THE PORT AUTHORITY OF NY & NJ

We are requesting authorization to approve proposed concrete mix proportions on the satisfactory results of one laboratory trial batch and not the typical four at the World Trade Center (WTC) Redevelopment project.

INTERACTION FLOW CHART AMONG OWNER, NYC DEPARTMENT OF BUILDINGS, & PORT AUTHORITY OF NY&NJ FOR EXCAVATION WITHIN 200 FEET OF ARC TUNNELS

Date of meeting: February 25, 2010
Location: NYC Department of Buildings, 280 Broadway, New York
Subject: ARC Project
Purpose: Discuss the procedural requirements for the notification of property owners who plan to construct/modify their property within the notification zone of the ARC Tunnel project.

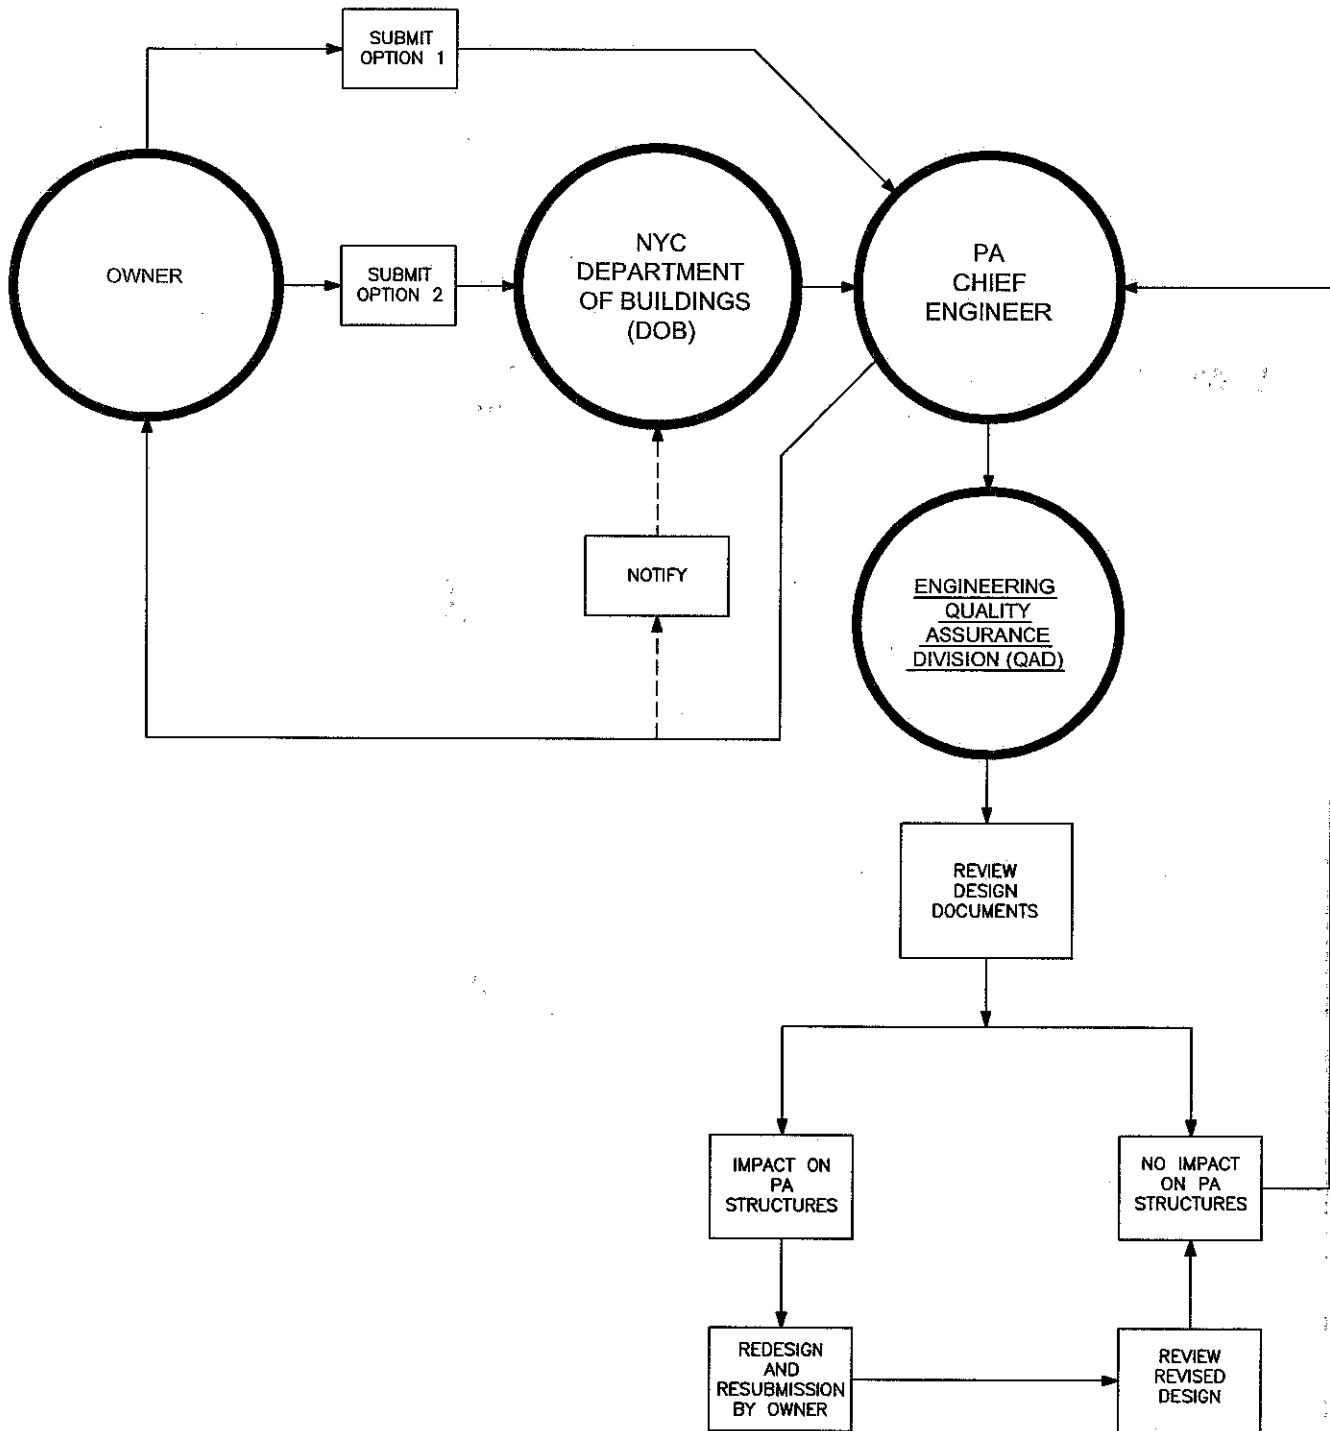
7. The Interaction Flow Chart among the Property Owners, PA, and DOB that was previously given to DOB was discussed. Suggestions were made to substitute the approval and disapproval process with one that will require the owner to redesign and resubmit to the PA until the design achieves "no Impact" on ARC underground structures. PA will modify the flow chart and send to DOB.

8. FL assigned Saroj Bhol (SB) to be the point of contact for the PA with DOB. It was agreed to provide DOB a modified flow chart, information on the properties that fall within the Notification Zone, and a copy of the current planned ARC pre-construction and construction program in preparation for drafting an MOU.
